City of Pensacola

Zoning Board of Adjustments

ZBA 2023-010
4590 Christy Drive
R-1AAA

**City of Pensacola Building Inspections Dept.
Plan Review Correction List**

Photo 1

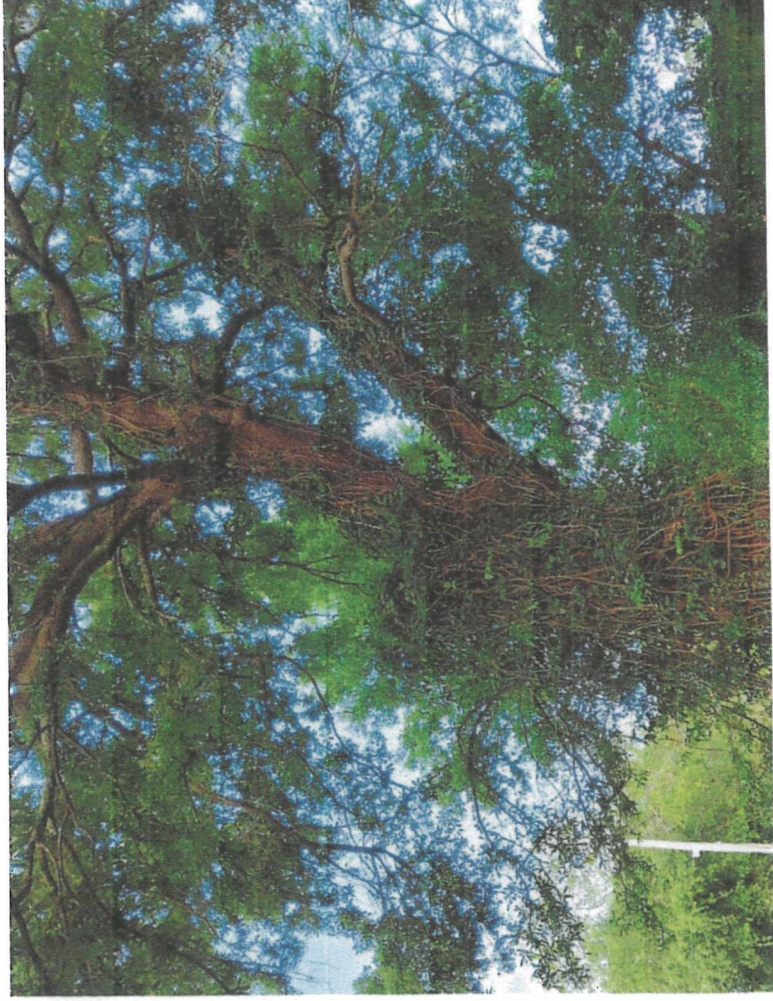
Overview of Tree 1, facing west. Note the dense vine cover present throughout the tree.
